APPROVED
Limited building only review
Permit holder responsible for full compliance with the code

289 BRET ROAD RESIDENCE
CAMERON, HARNETT COUNTY, NORTH CAROLINA

SHEET TITLE:
ELEVATIONS / BUILDING DATA

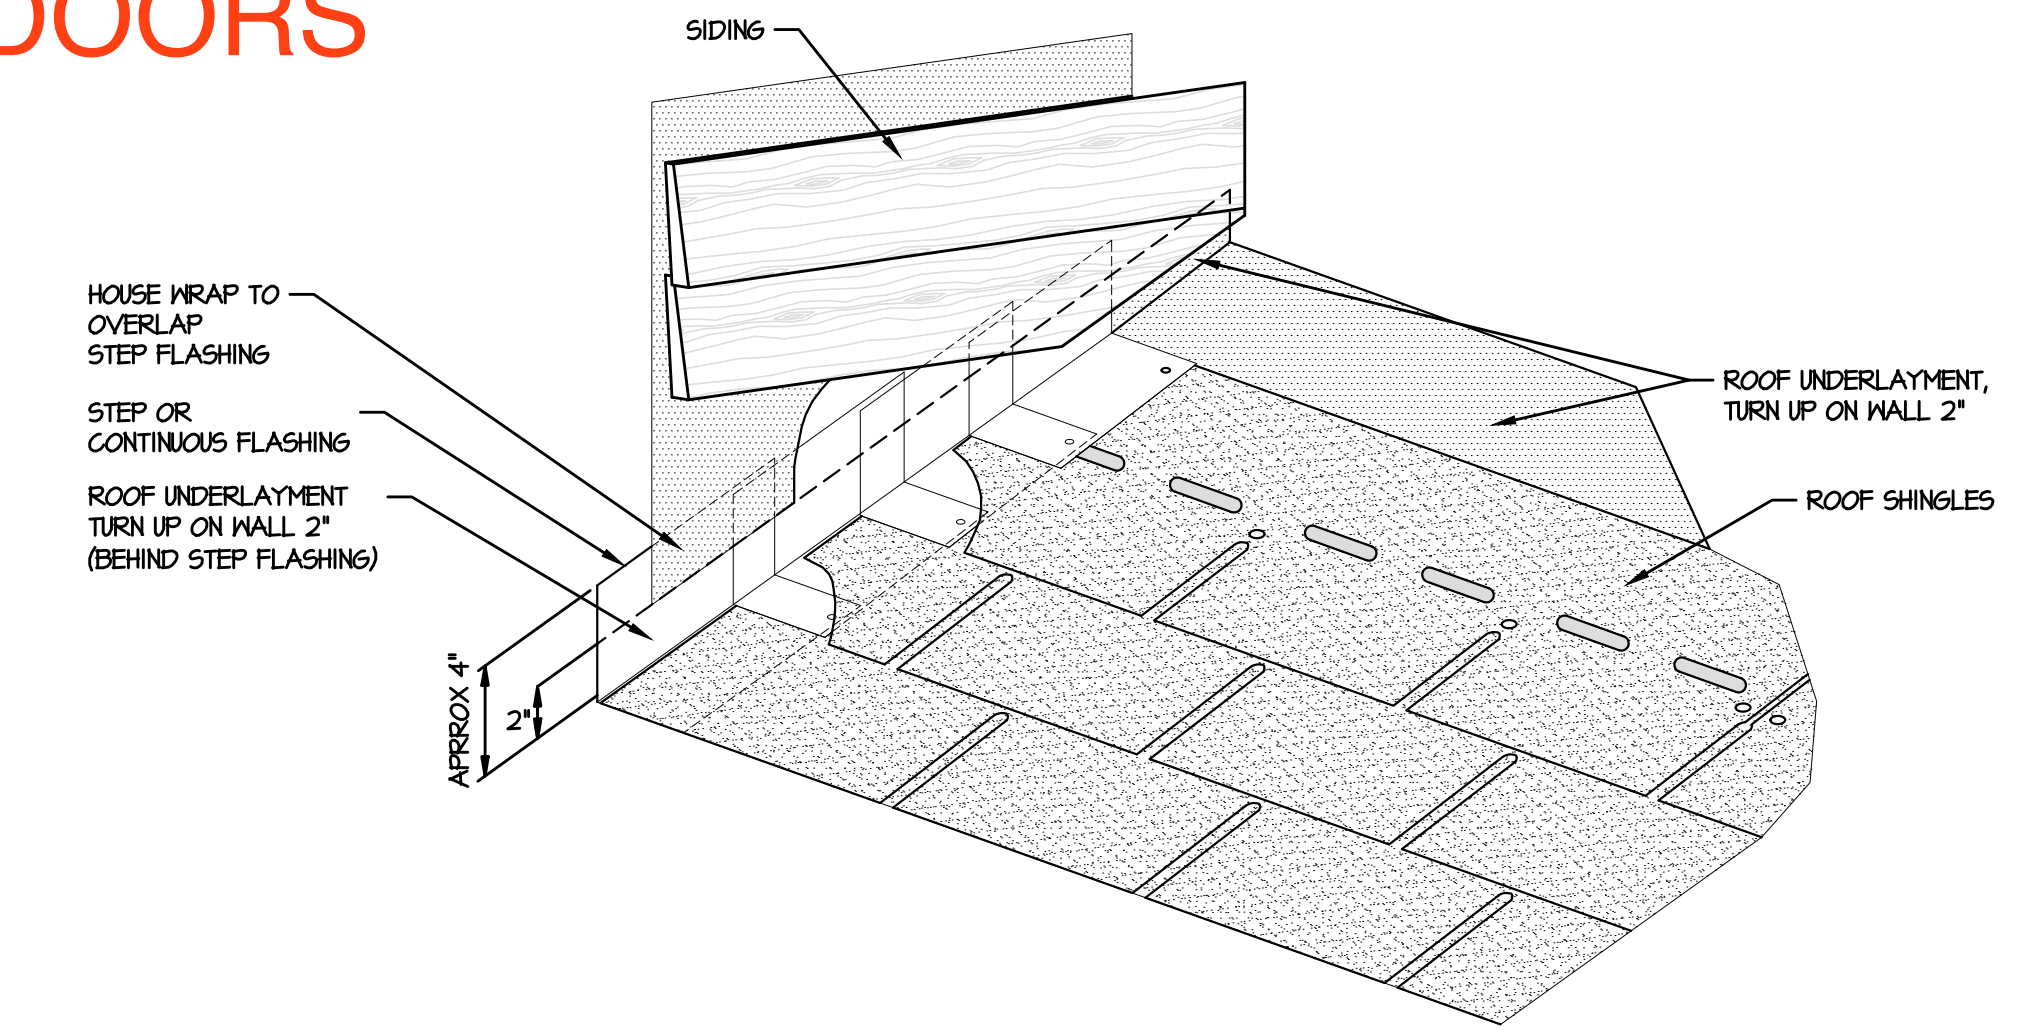
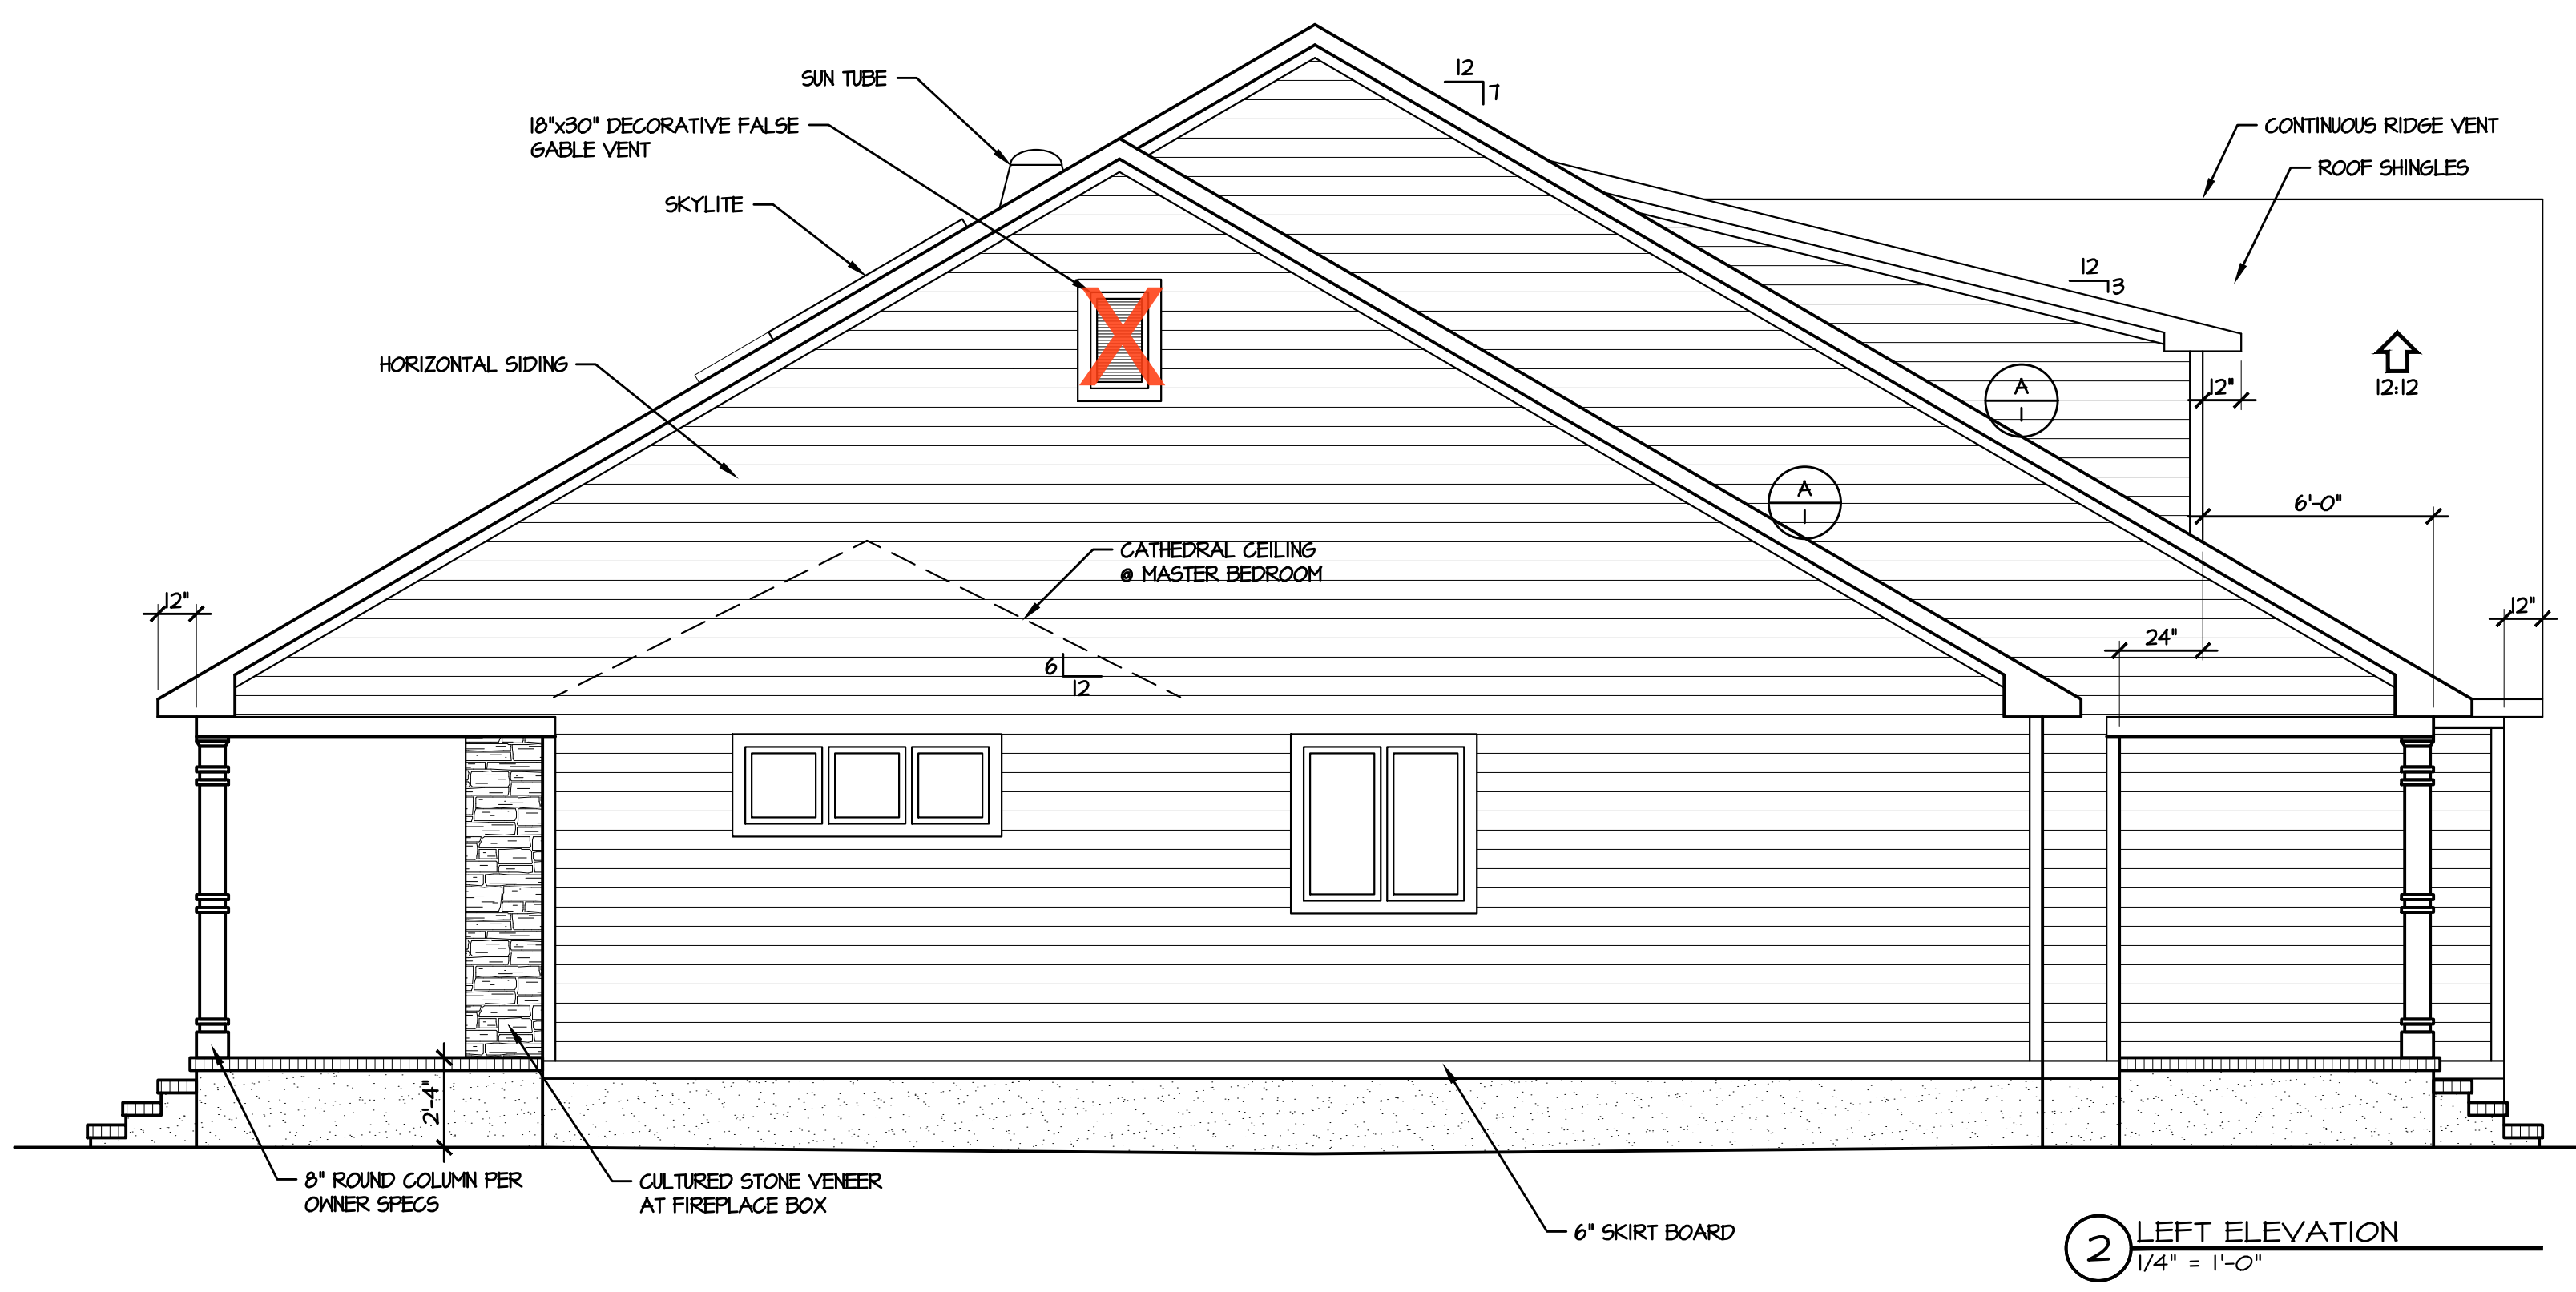
8 FOOT TALL GARAGE DOORS

1 FLOOR PLAN
1/4" = 1'-0"

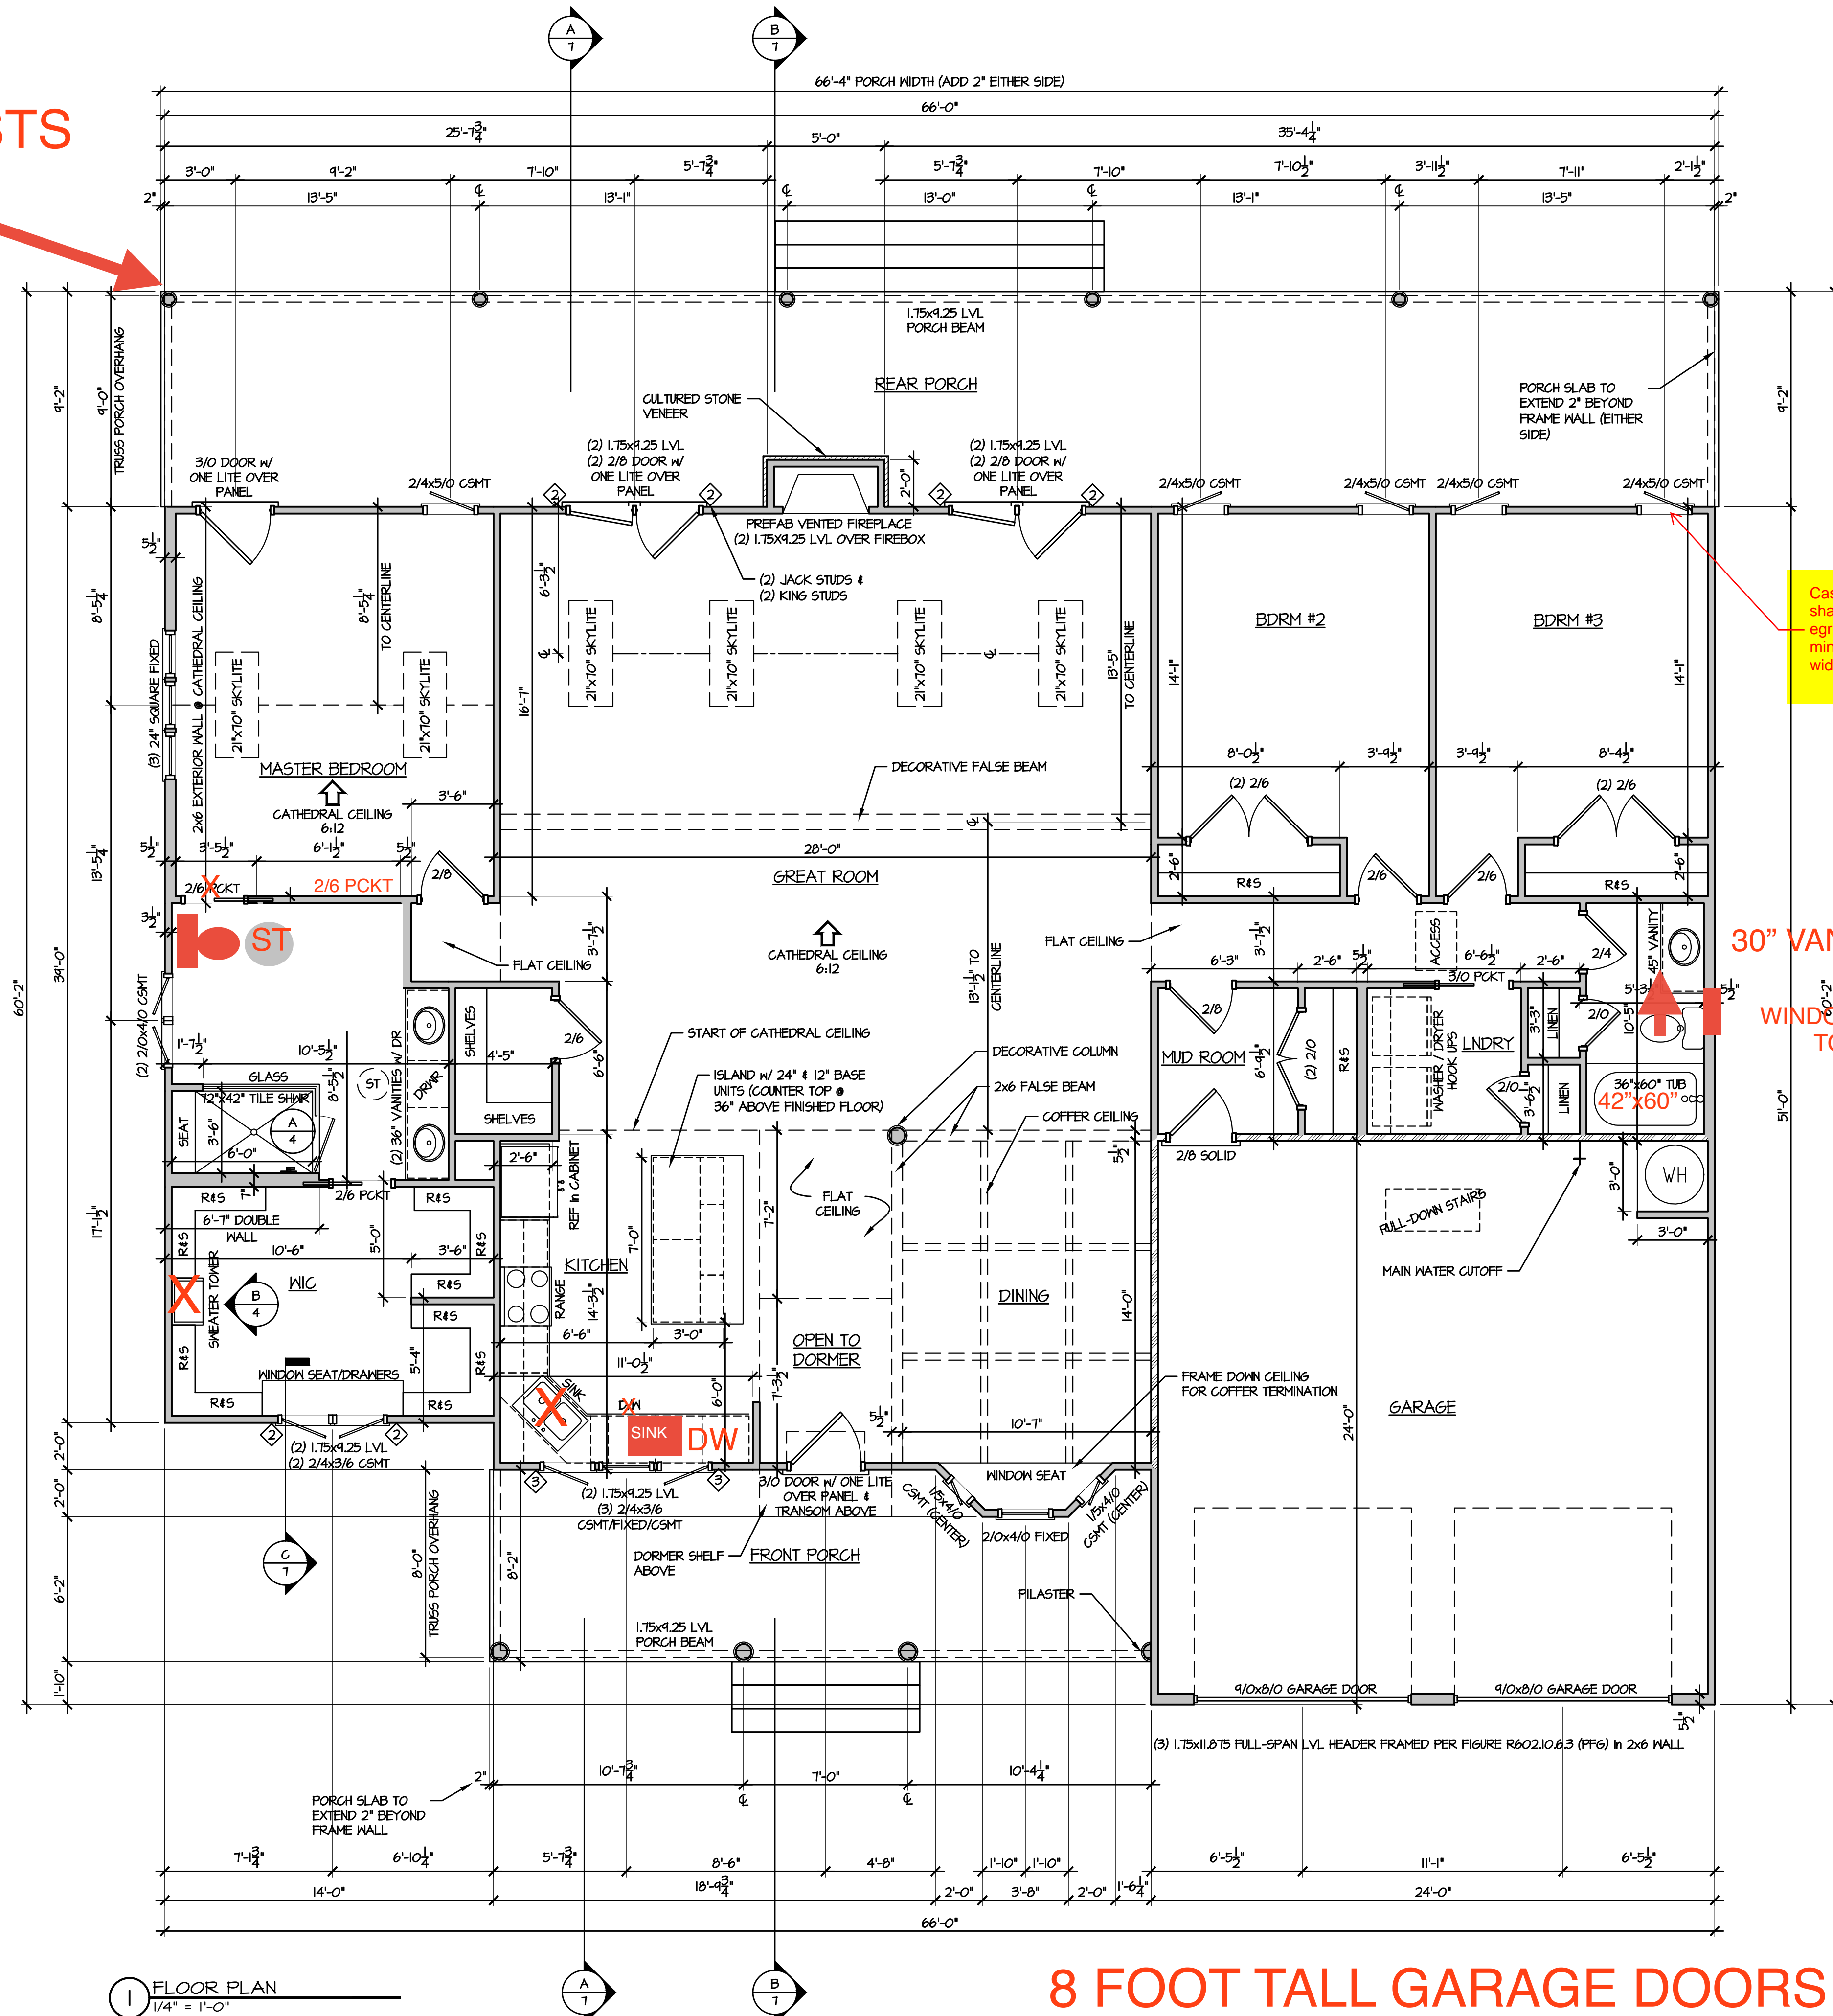
Caseмент windows shall have side hinge egress kits to meet minimum clear egress width of 20"

30" VANITY WINDOW ABOVE TOILET

8 FOOT TALL GARAGE DOORS
